Warranty Bulletin

WB24-80A

DEF DECAL REPLACEMENT 9700 (B13R)

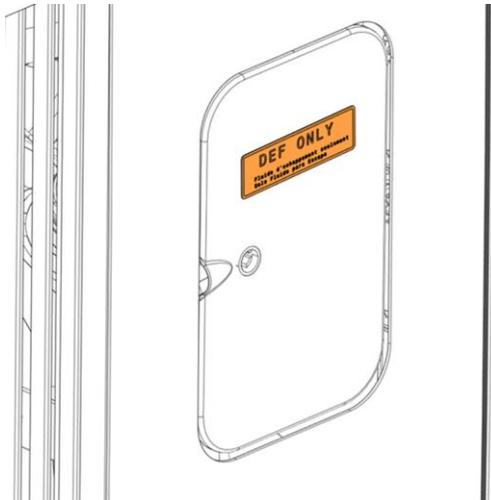
2. Remove the old DEF decal outside of door.
Clean the surface with alcohol.

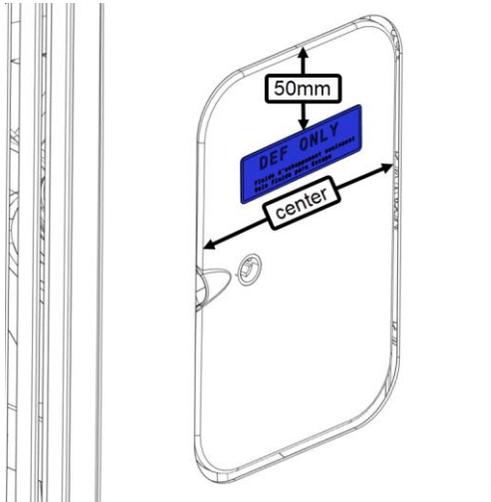
3. Install the new outside decal 21467930 at
same position of the older one.

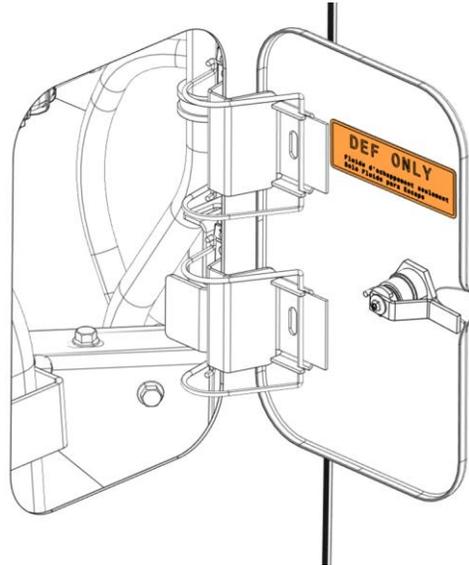
4. Remove the old DEF decal inside of door.
5. Clean the surface with alcohol.

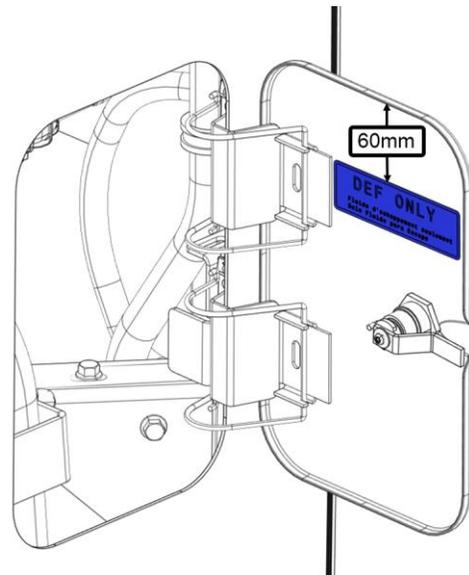
6. Install the new inside decal 21467930 at same position of the older one.
